MARINE AND COASTAL ACCESS ACT (2009). APPLICATION FOR A MARINE LICENCE BY MONA OFFSHORE WIND LIMITED FOR THE CONSTRUCTION AND OPERATION OF THE TRANSMISSION ASSETS FOR MONA OFFSHORE WIND FARM OFF LLANDDULAS NORTH WALES EAST IRISH SEA.

Reference Number: ORM2429T

From: Sylvia Blake
Cefas, Lowestoft Laboratory
Date: 13th August

Figure 1 location of the proposed Mona array disposal site.

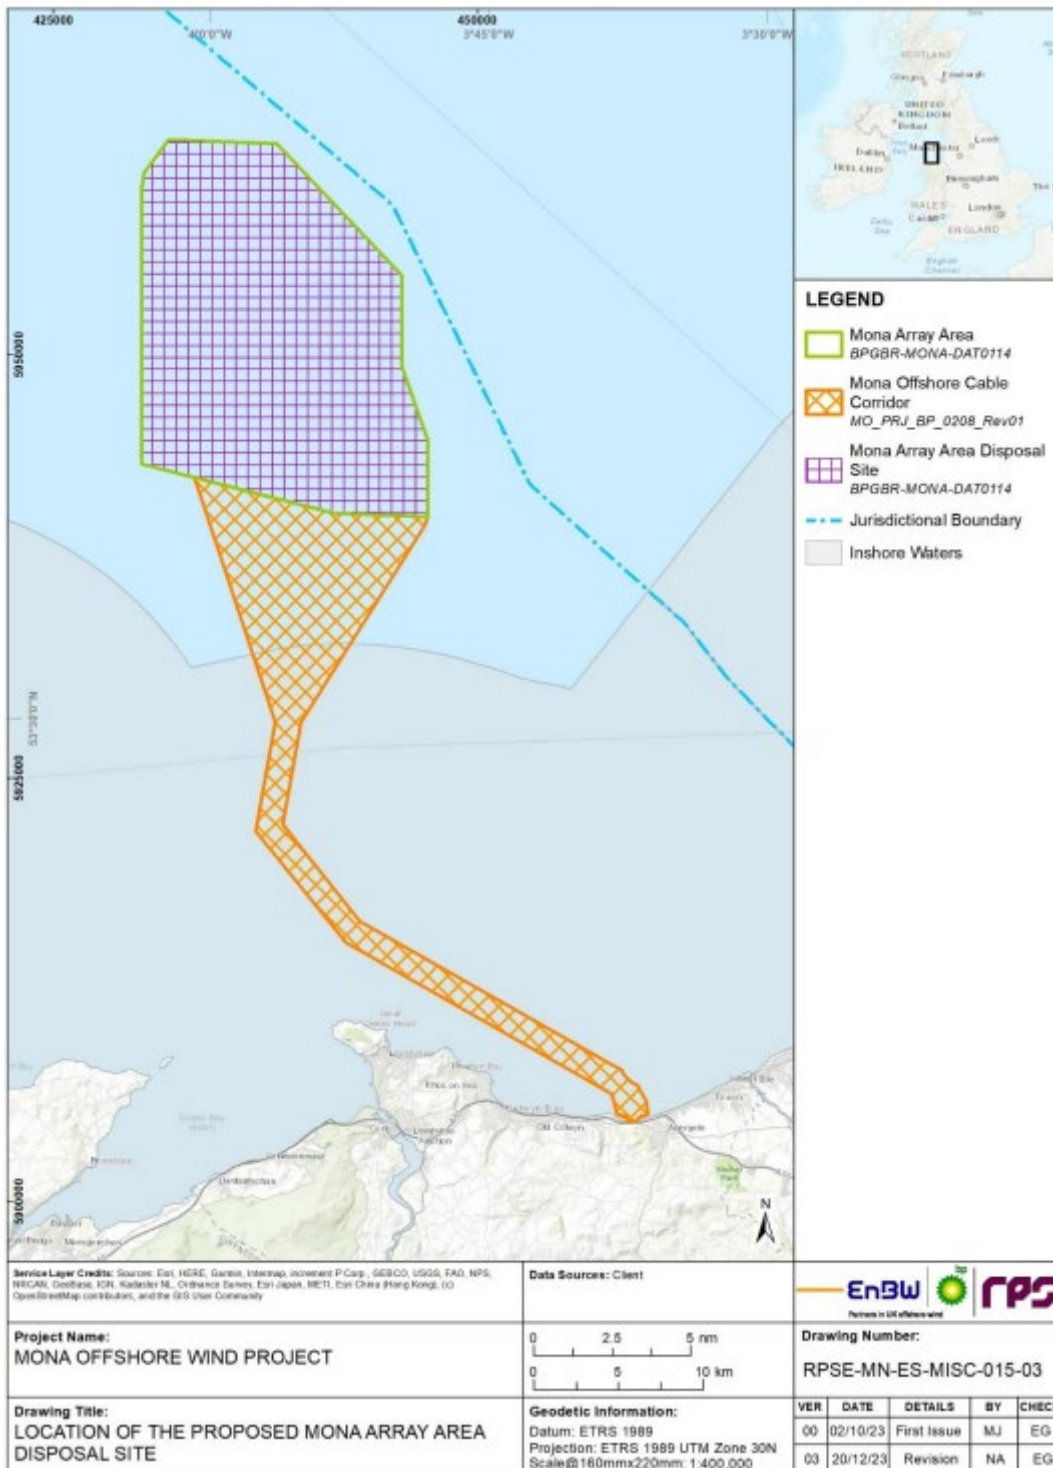
adjacent to the foundation.” The proposed disposal site is therefore within the array area or cable corridor (Annex 1 figure 1).

pragmatic to designate one site for both areas. (area of the array- Annex 1 figure 1, and the area of the offshore cable corridor - Annex 1 figure 2).

Figure 2 location of the proposed Mona offshore cable corridor disposal site.

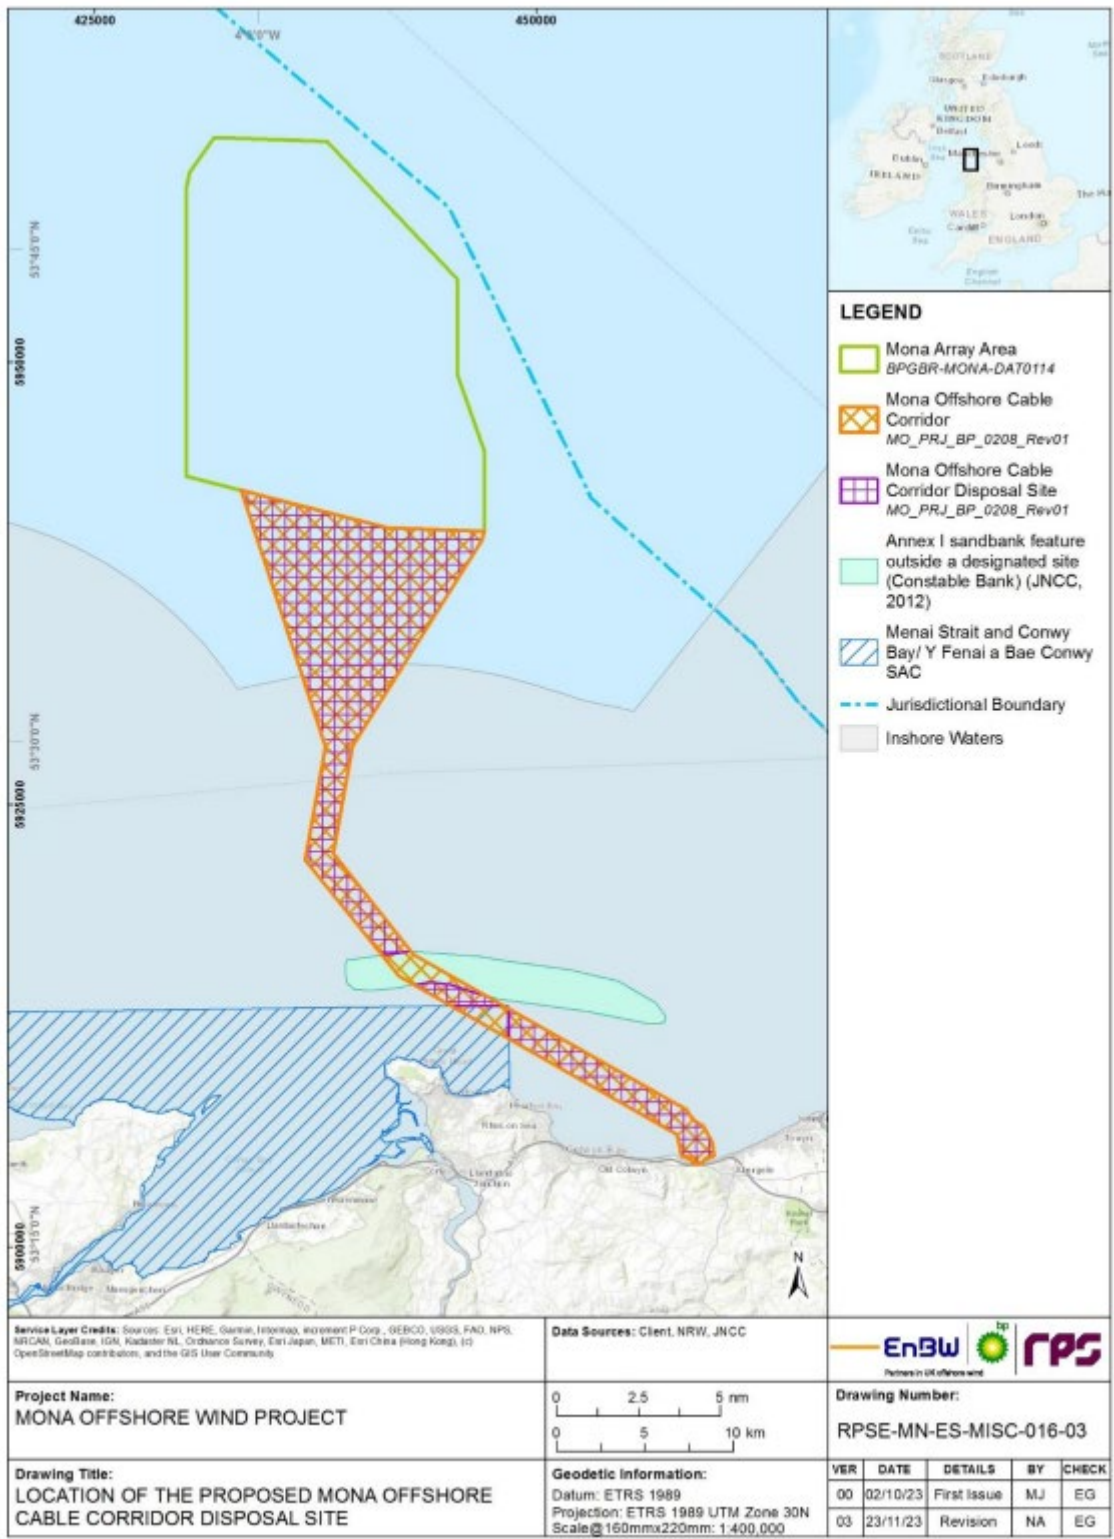
32. **Minor comment (Action):** Plotting the area of the disposal sites from the co-ordinates provided in the shape file show the offshore cable corridor to be split into 3 areas (figure 3) however the figures in the characterisation reports (documents 8 and 9 figures 1 and 2 copied in Annex 1 below) show the area of the offshore cable corridor to be continuous, therefore I have assumed that the area to be designated would be continuous and the applicants shape file needs amended, unless there is a specific reason for the separation.

- 40. If NRW determine require the array area and the export cable corridor designated although there is no clear advantage of either designating these together or separately, as the applicants intend to dispose of dredged material close to the extraction site and that both areas being adjacent may find some deposition from works adjacent to their site, for efficiency the suggestion is for one disposal area to be opened if required for the sole use of the construction and operation/maintenance works at Mona to be closed upon completion of the works. The disposal site shape file should be amended for the offshore cable corridor to be continuous (as per comment 32).
